GeoSolve Ref: 220556.03  
26 November 2025

RCL Homestead Bay Ltd  
[REDACTED]

## Request for Further Information - Homestead Bay Lot 12 DP 364700

Liquefaction results for CPT4

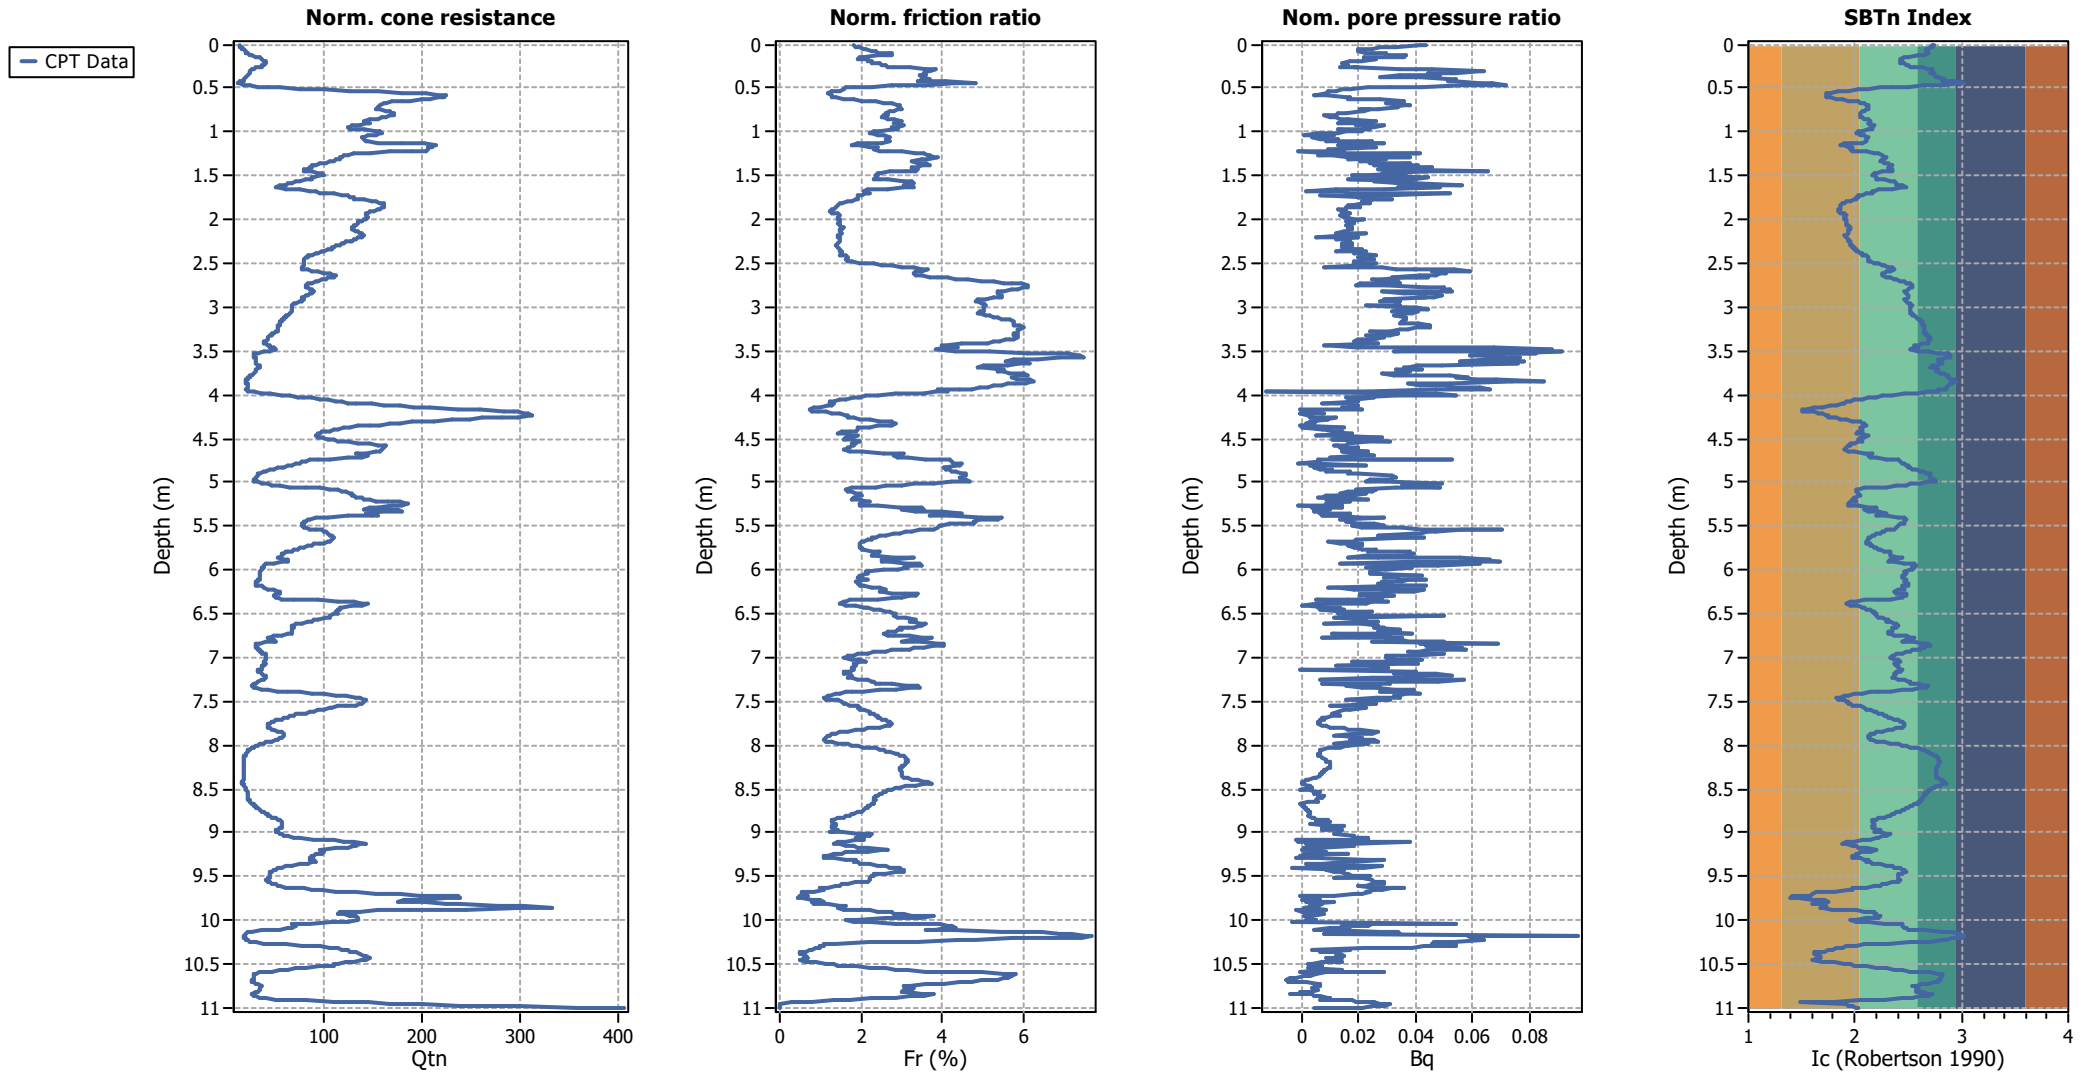
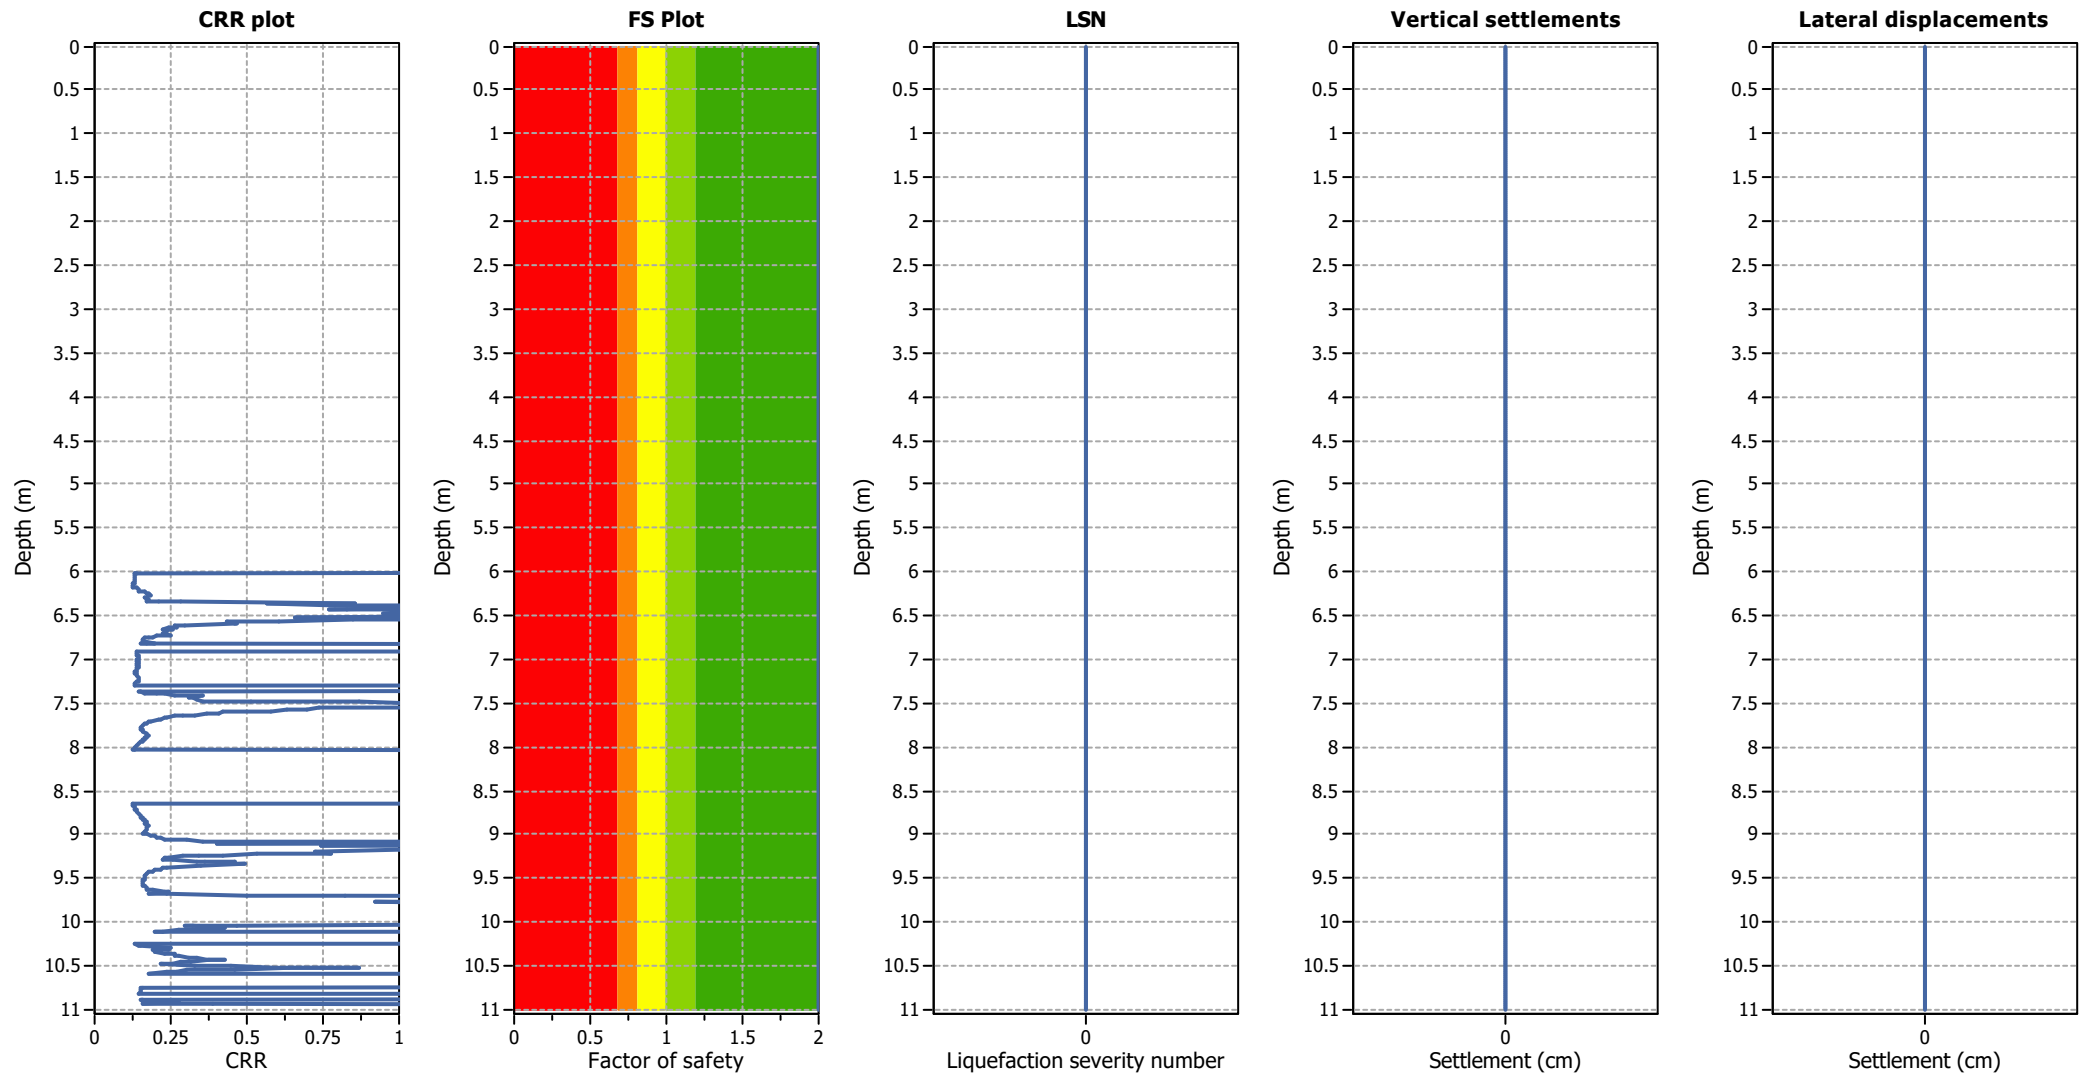
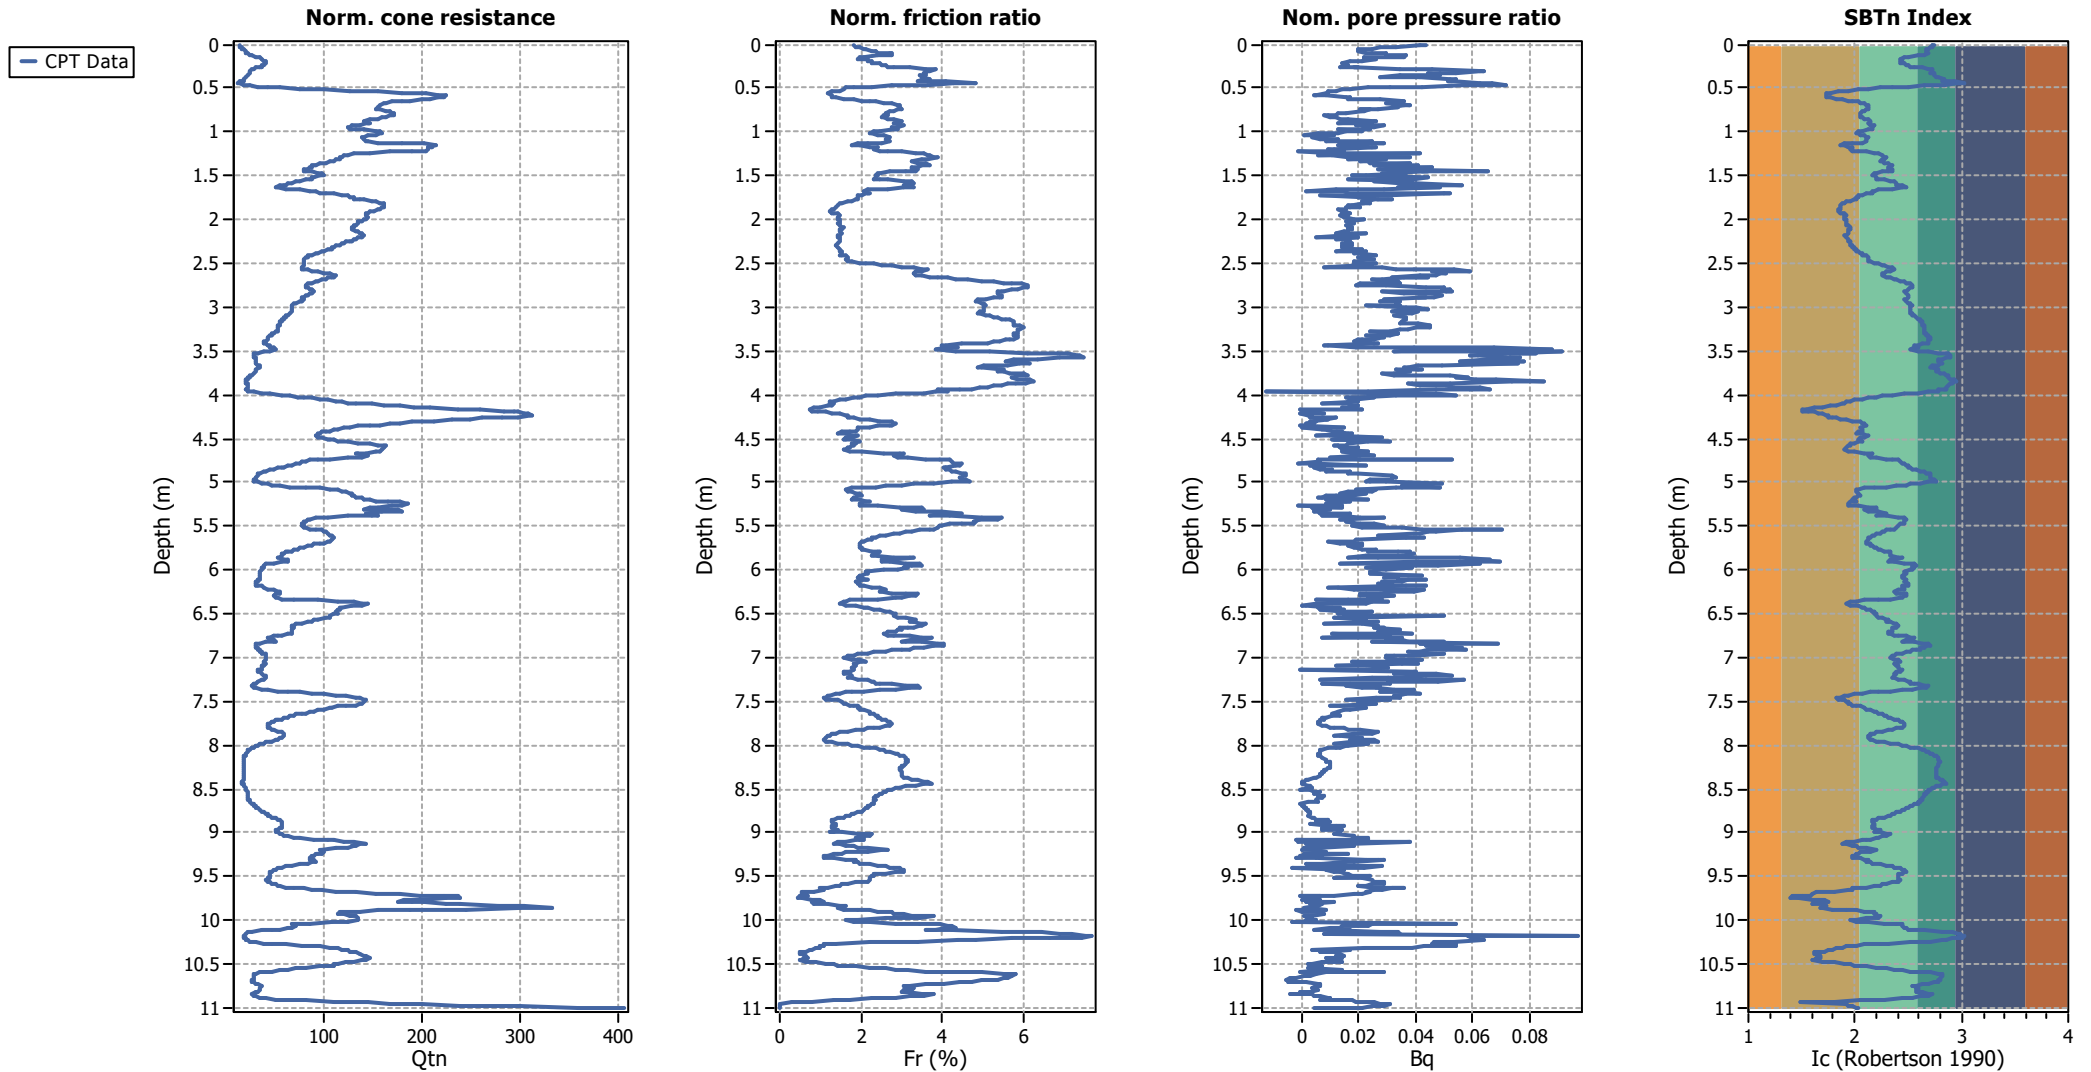
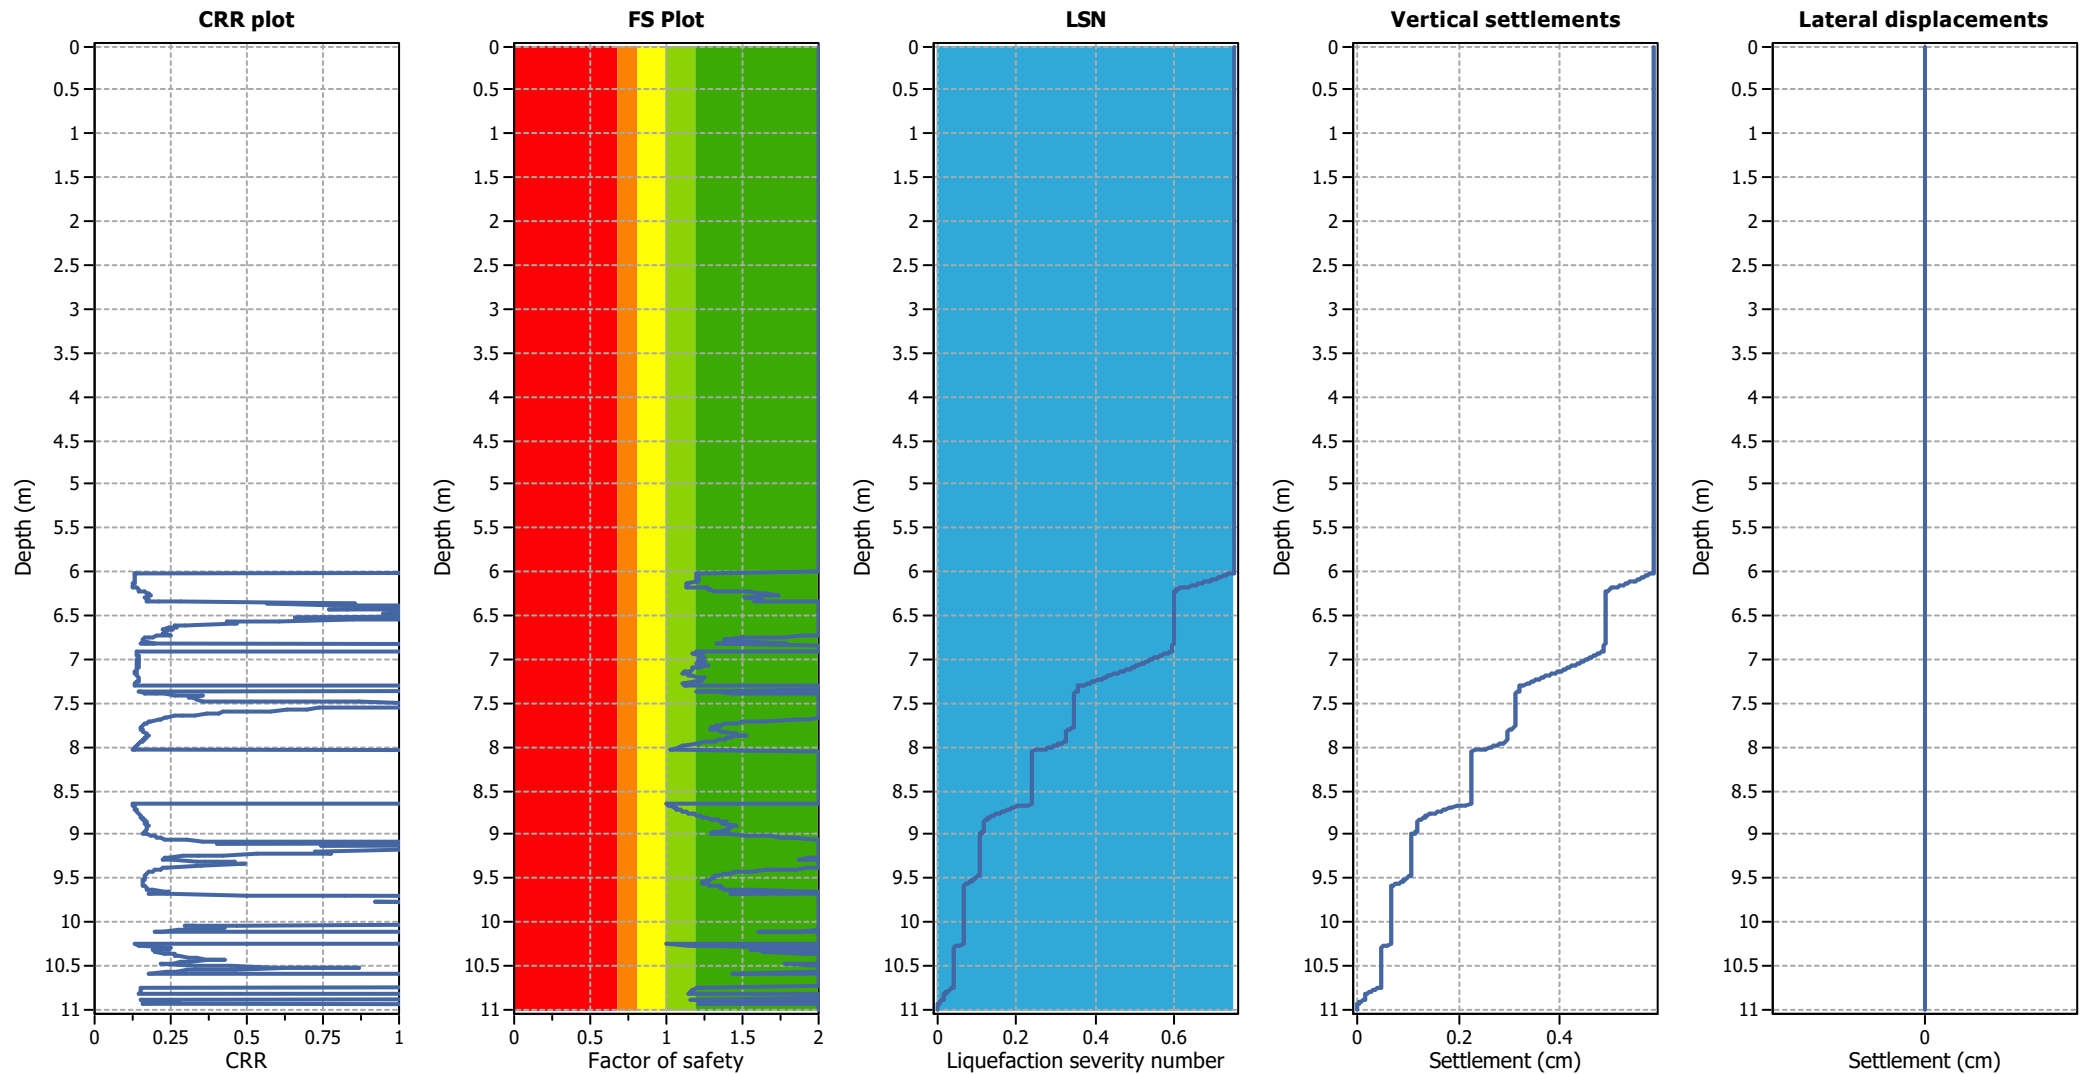
21.	The liquefaction analysis undertaken for CPT 4 was for both IL3 and IL4 – QLDC requires reservoirs and WTP to be designed for IL4, so the results for IL4 have been considered. The liquefaction analysis undertaken from CPT 4 shows settlements for IL4 SLS2 (1 in 500) and ULS (1 in 1000) of 50mm and 60mm respectively. Appendix H does not conclude the classification of the liquefaction risk, but it does refer that “the liquefaction risk to be similar to eastern areas of the wider Homestead Bay site to the south” which stated: medium vulnerability, the initial report states it can be mitigated with robust foundation slabs similar to MBIE TC2 slabs (pg 511 of Eng Report Part 2). This mitigation was provided for residential buildings.
-----	---

Based on the liquefaction assessment Geosolve consider the liquefaction vulnerability to be Medium. This is based on the following:

- Liquefaction settlements of 50 mm have been calculated for a 1/500 year event.
- Differential settlements are expected to be Less than 50 mm, but may be 25 mm;
- No lateral spread is expected.
- The calculated liquefaction for a 100 year event is <10 mm, which is considered to be none to minor.
- Larger seismic events (1/2500 yr) result in relatively minor incremental settlement.
